Re: DM/23/2610 Land South of Hanlye Lane, Longacre Crescent, Cuckfield, West Sussex (Amended description and plans 24/06/2024)

I am writing to **object** to the proposed amended layout. The opportunity identified in the 'Statement of Common Ground' below has not been fulfilled in this plan.

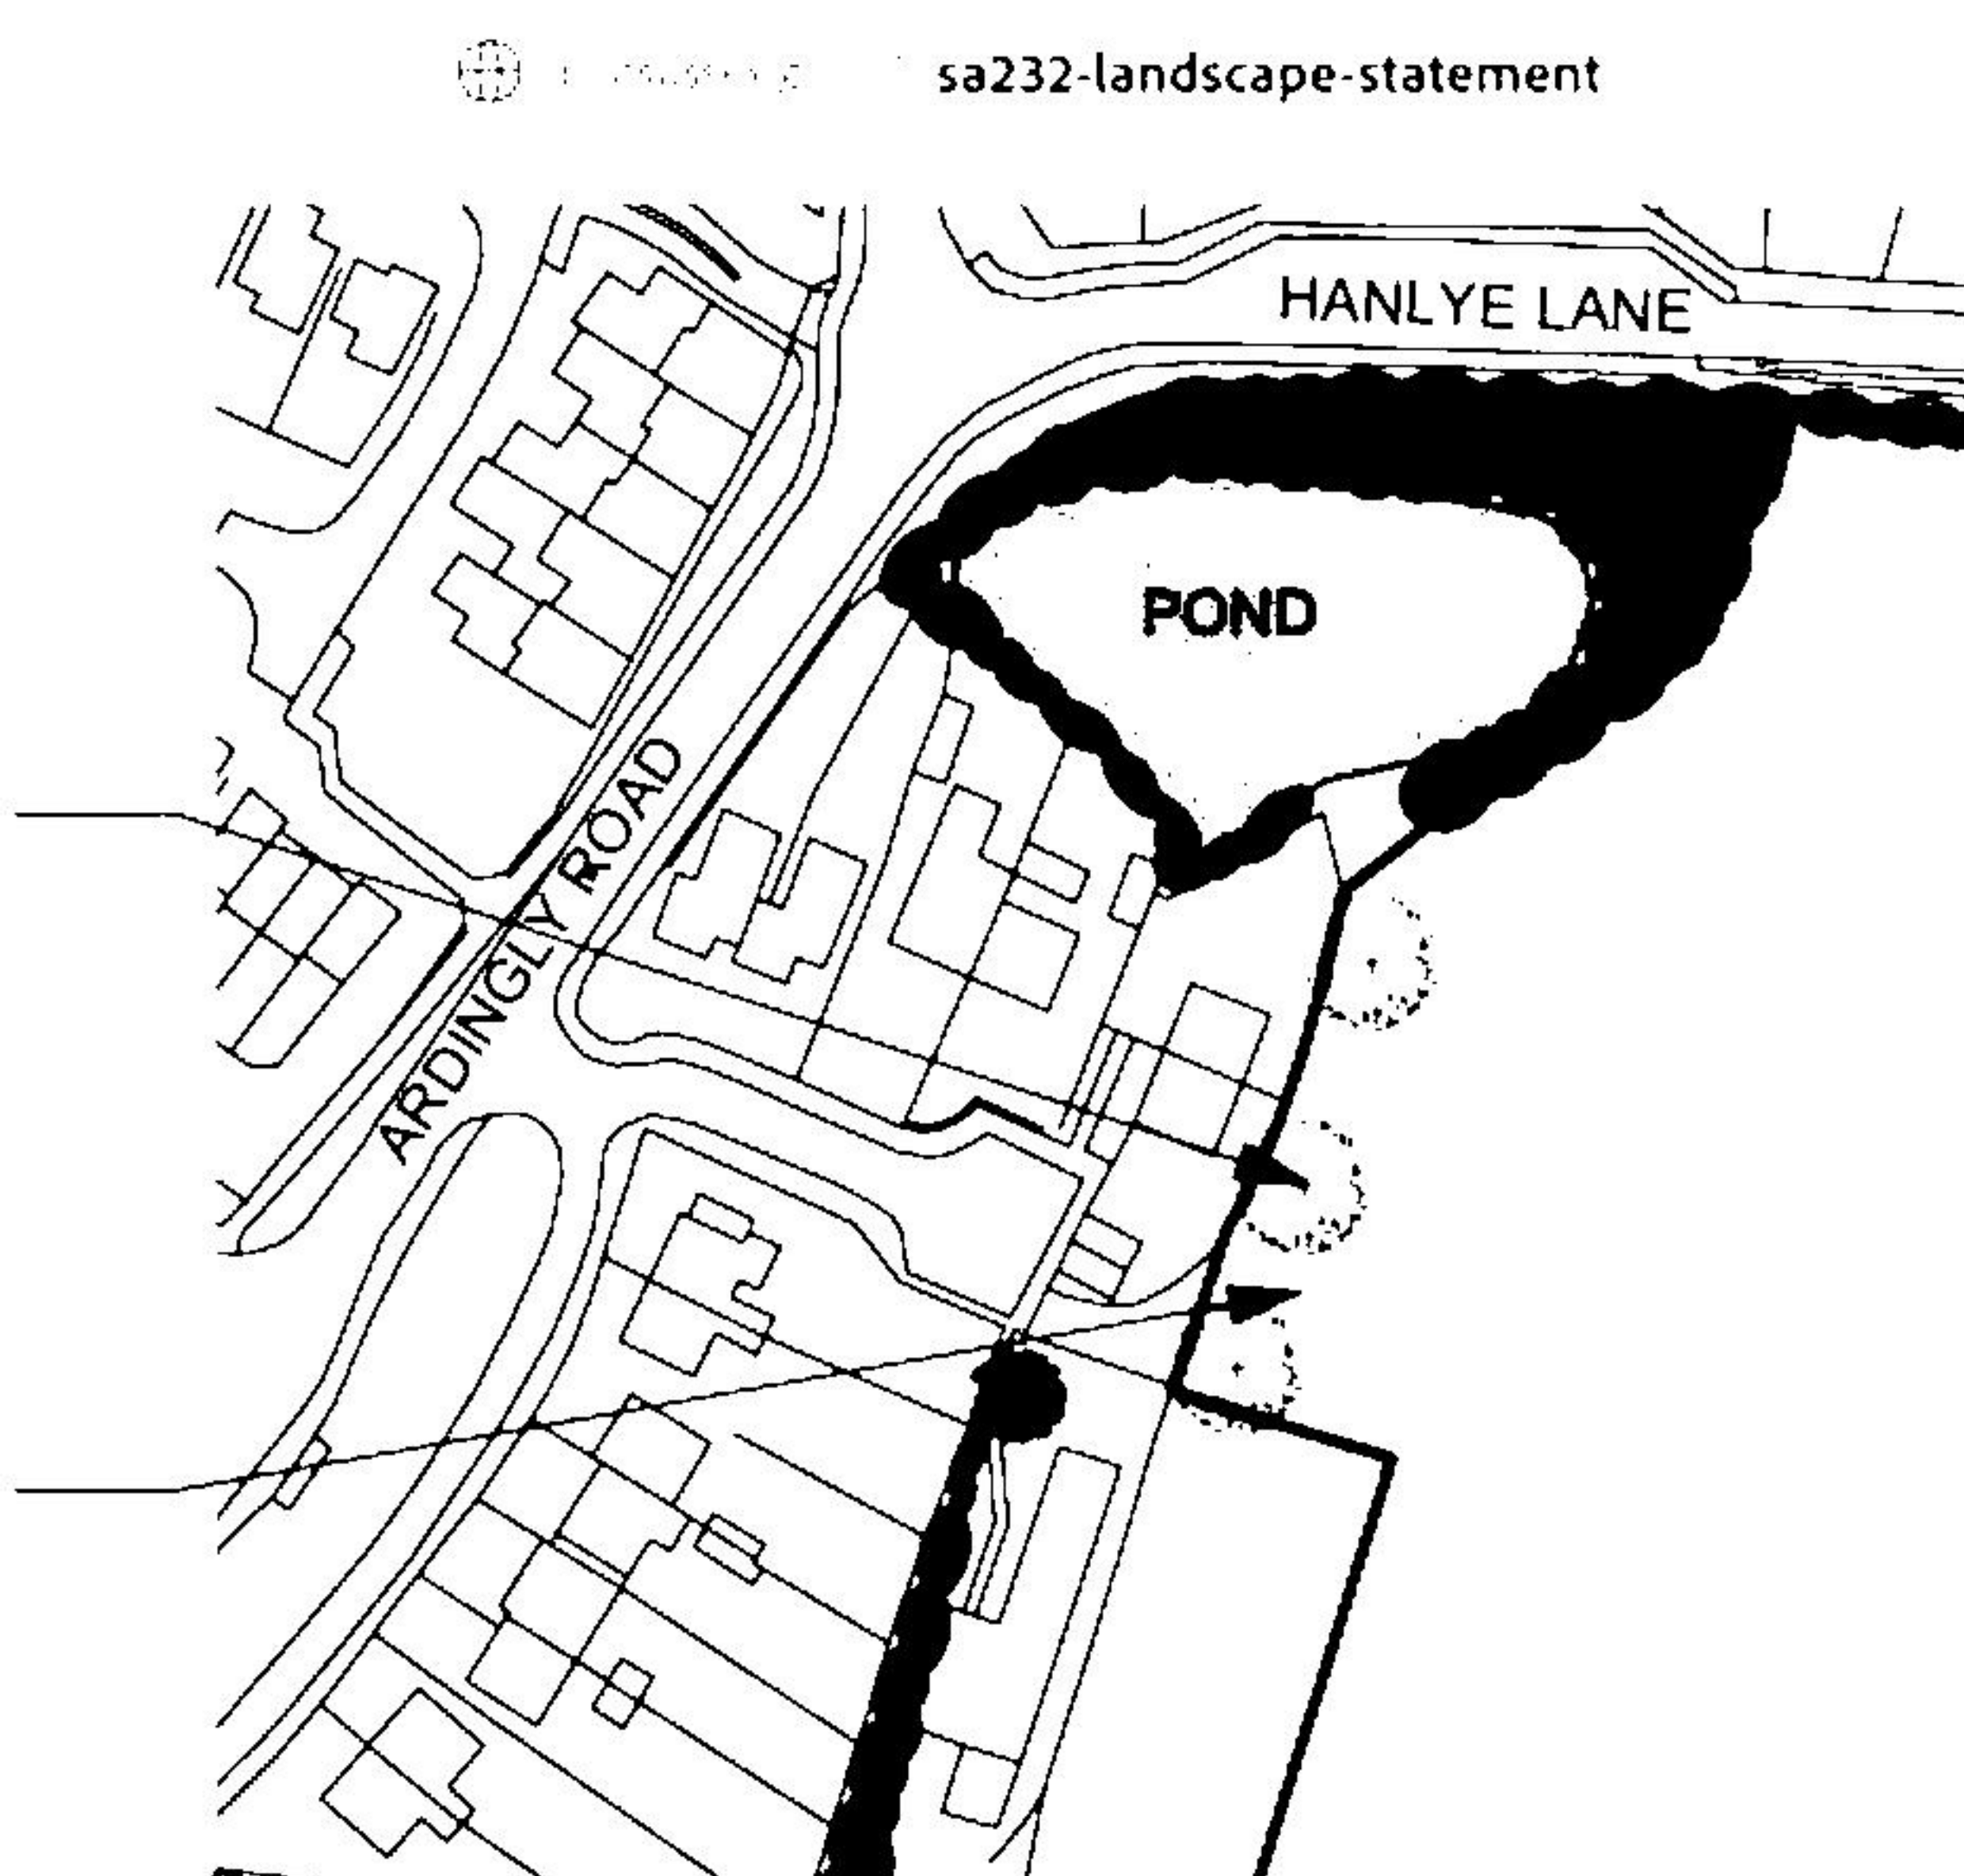
Further concerns: In addition to the concerns above we object to the current proposal as it fails to grasp more ‘opportunities’ that were discussed in the Opportunity and Constraints plans (p69) which laid out the following:

“Opportunity to enhance landscape buffer to existing dwellings to improve privacy and create biodiversity link with the pond”

“Vegetated buffer enhanced with additional native planting to maintain green link”

Opportunity to enhance landscape buffer to existing dwellings to improve privacy and create biodiversity link with the pond

Vegetated buffer enhanced with additional native planting to maintain green link

“Retain mature trees in centre of site, and enhance with additional planting to enhance existing landscape and wildlife green links throughout the site.”

The current plan sadly proposes destroying and building over the copse adjacent to the pond, and blocking wildlife movement from the pond south across the field by dividing it into individual gardens without leaving a ‘vegetated buffer’. This area is incredibly densely populated habitat for all manner of species who take advantage of the pond and it’s surrounds, including bats, newts, field mice and herons. A ‘green corridor’ from the established ponds to the proposed basins in the southern field, would be a way to greatly improve the plan.
